Dominion Nuclear Connecticut, Inc.  
Millstone Power Station  
Rope Ferry Road  
Waterford, CT 06385

Millstone Power Station, Unit No. 2  
Technical Specifications Change Request (TSCR) 2-10-01  
Fuel Pool Requirements

Technical Specification Change Request (TSCR) 2-10-01  
Fuel Pool Requirements  
Discussion of Proposed Changes and Safety Summary

FIGURE 3.9-1B MINIMUM REQUIRED FUEL ASSEMBLY EXPOSURE AS A FUNCTION OF INITIAL ENRICHMENT TO PERMIT STORAGE IN REGION C WITH POISON PINS INSTALLED

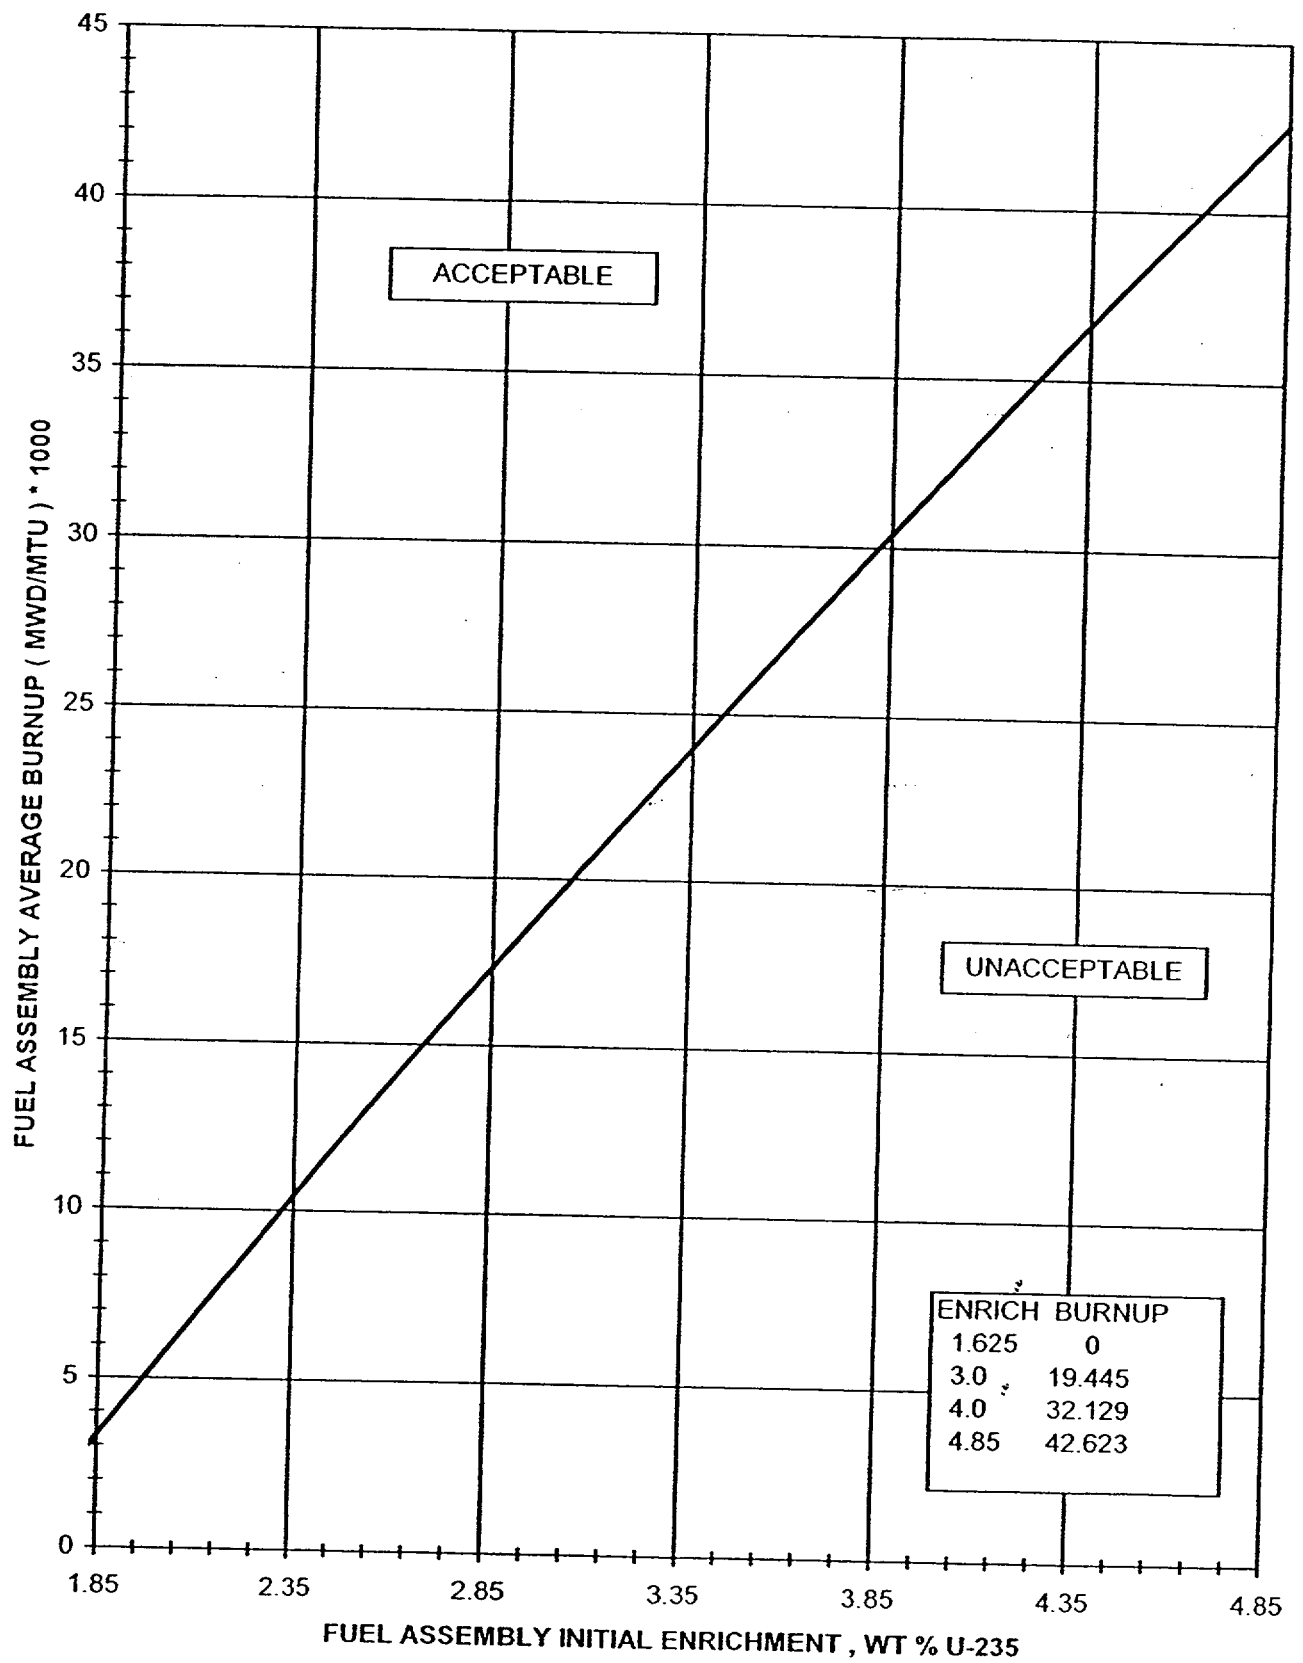
This TS figure shows the minimum required fuel assembly exposure as a function of initial enrichment to permit storage of fuel assemblies in Region C, with poison pins installed. This TS figure is revised to reflect the revised criticality analysis.

The values shown in this Figure are taken from the criticality analysis that is attached. The required burnups shown in the proposed Figure 3.9-1B are slightly smaller than the current limits due to soluble boron credit.

FIGURE 3.9-4 MINIMUM REQUIRED FUEL ASSEMBLY EXPOSURE AS A FUNCTION OF INITIAL ENRICHMENT TO PERMIT STORAGE IN REGION A

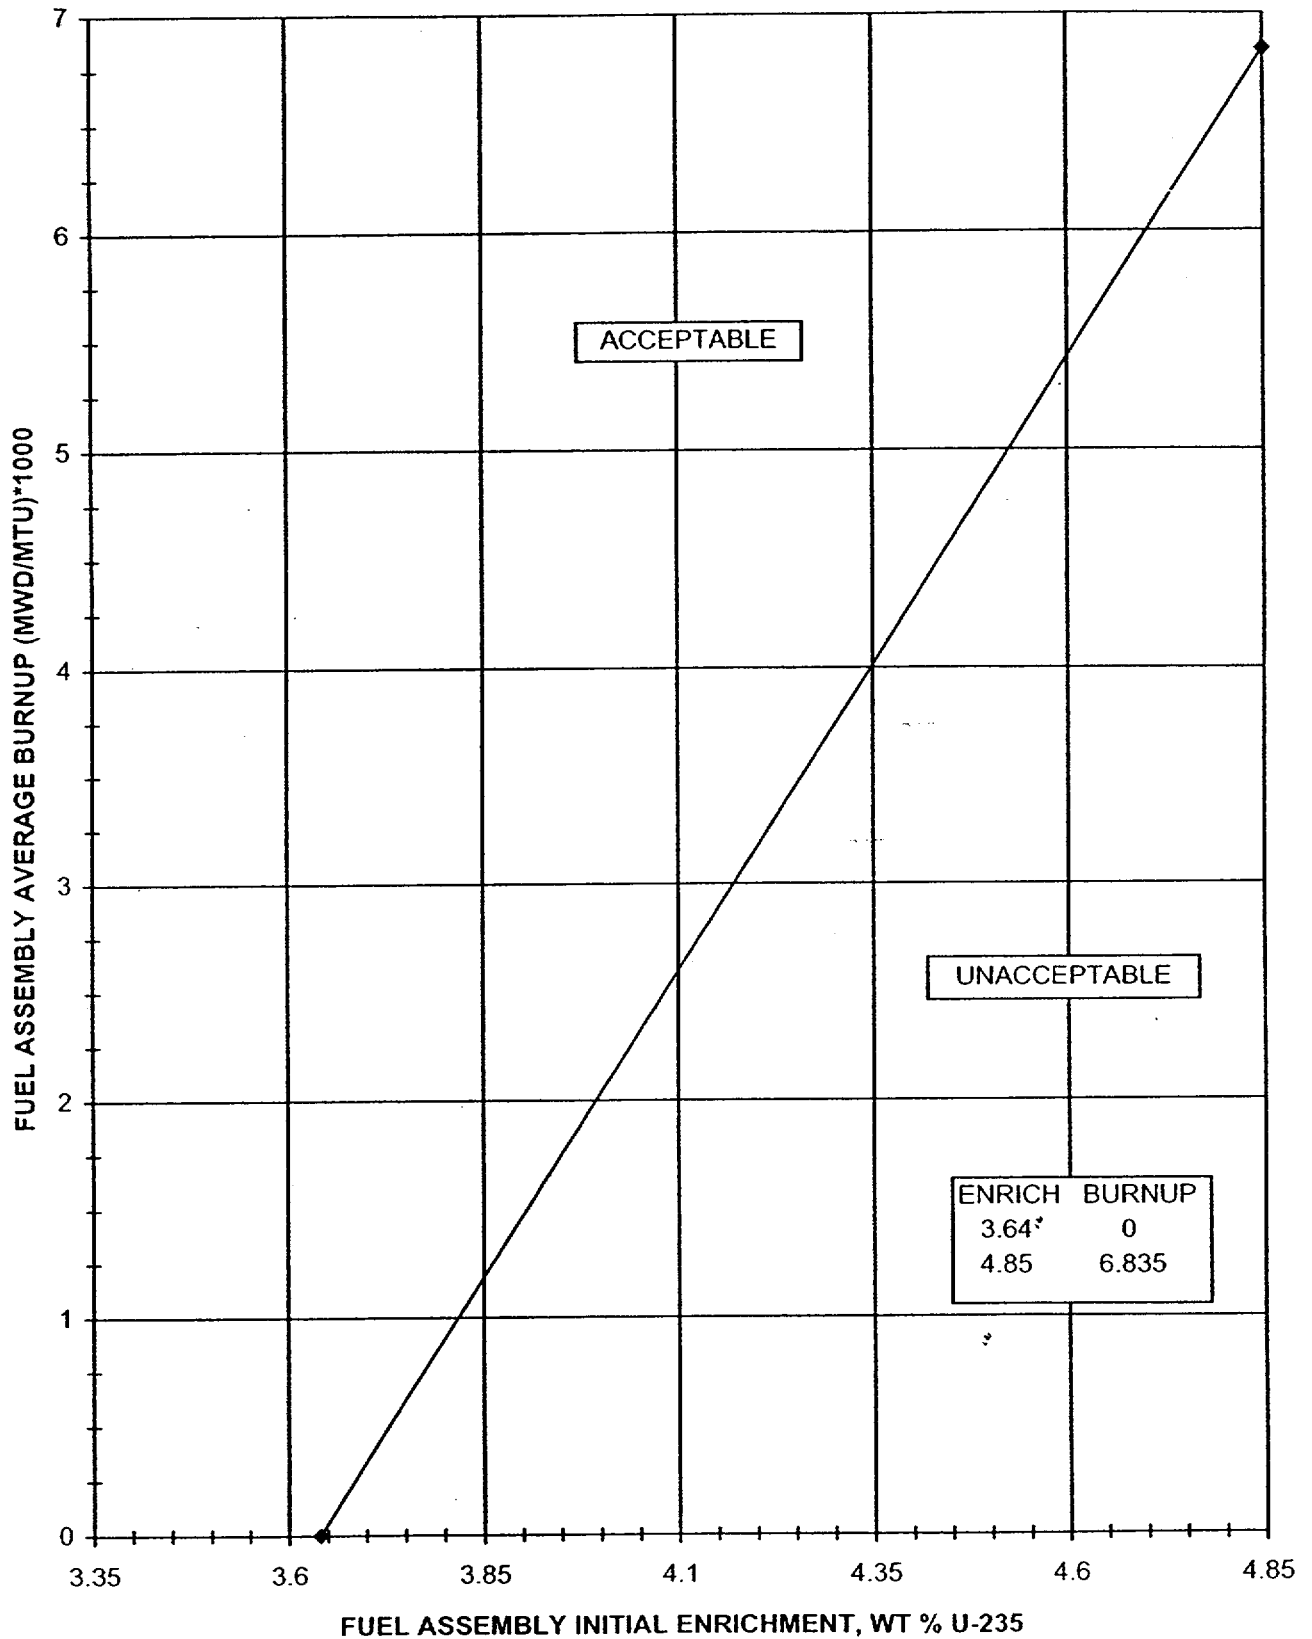
This TS Figure shows the minimum required fuel assembly exposure as a function of initial enrichment to permit storage of fuel assemblies in Region A. This TS figure is revised to reflect the revised criticality analysis.

The values shown in this Figure are taken from the criticality analysis that is attached. The required burnups shown in the proposed Figure 3.9-4 are slightly smaller than the current limits due to soluble boron credit.
